# Service Bulletin

Bulletin No.: 14-00-89-002

**Subject:** Important Fuse Replacement Requirement

**Models:** 2014 Cadillac XTS Professional Vehicles

3717175

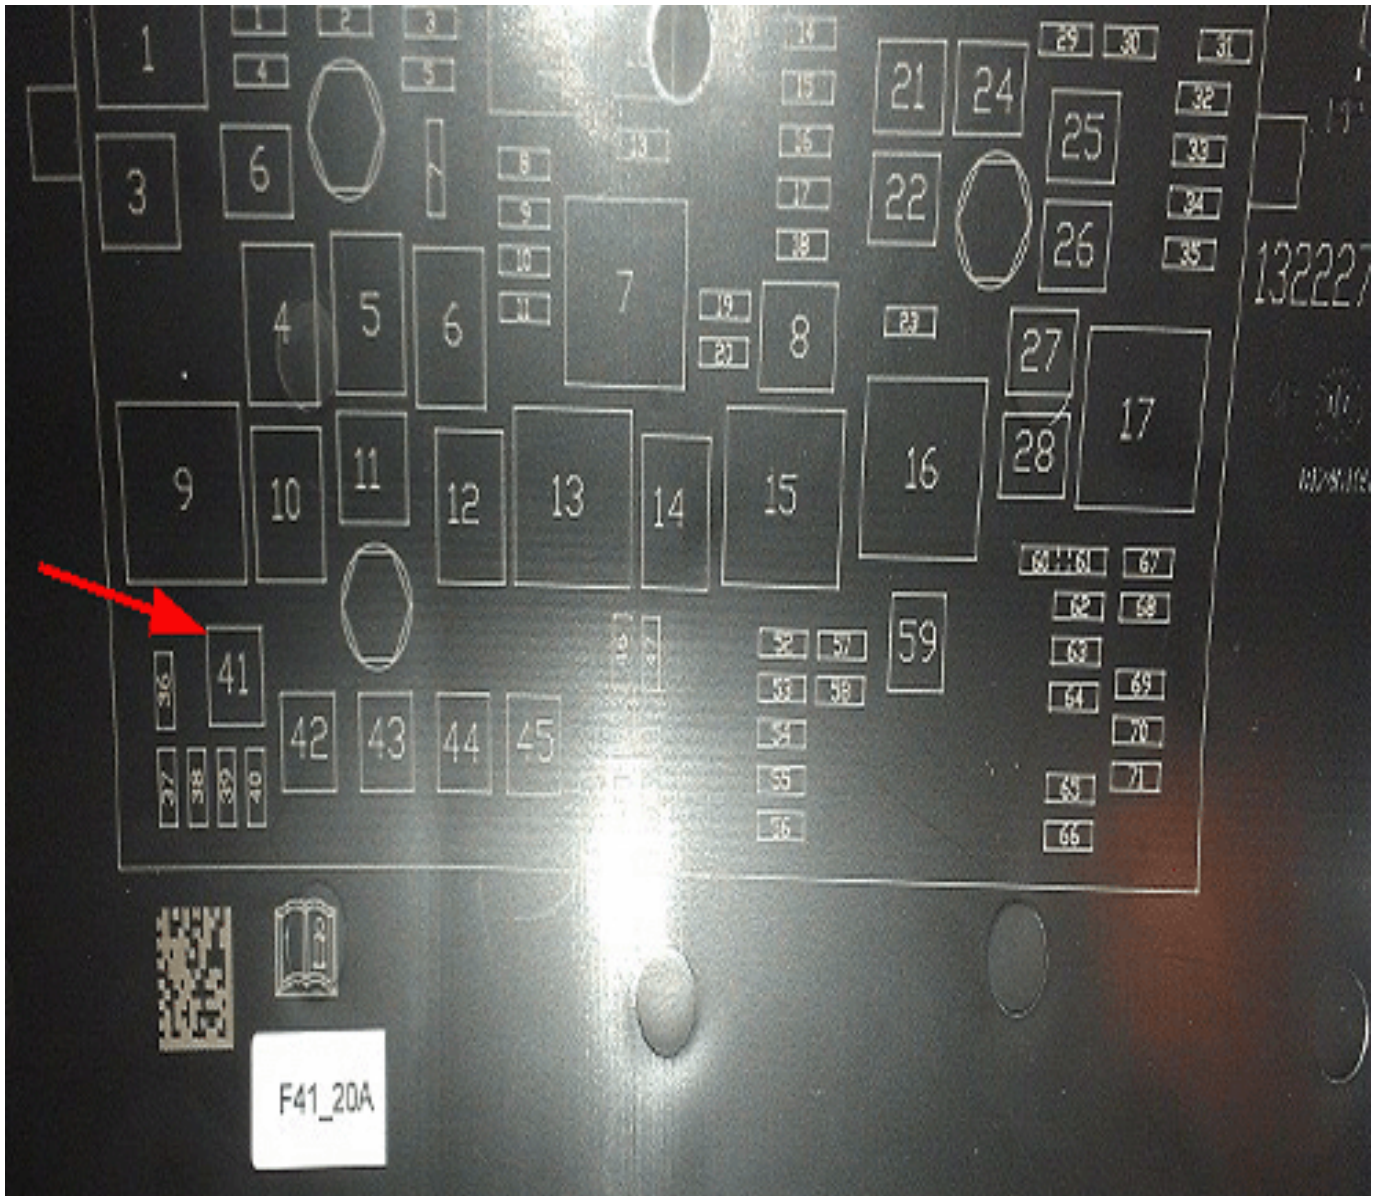
Current XTS professional vehicles share a number of components with the base XTS chassis. Based on some current production changes, the base XTS will now have a 20 amp fuse placed in cavity 41 in the front fuse block, as shown in the illustration above.

Cadillac Master Coachbuilders will need to remove the 20 amp fuse and replace it with a 25 amp fuse to ensure proper load capabilities for the professional vehicle. You will also need to remove the added 20 amp fuse label shown in the photo. This fuse change will be required until further notice and is required on all Professional Vehicles.
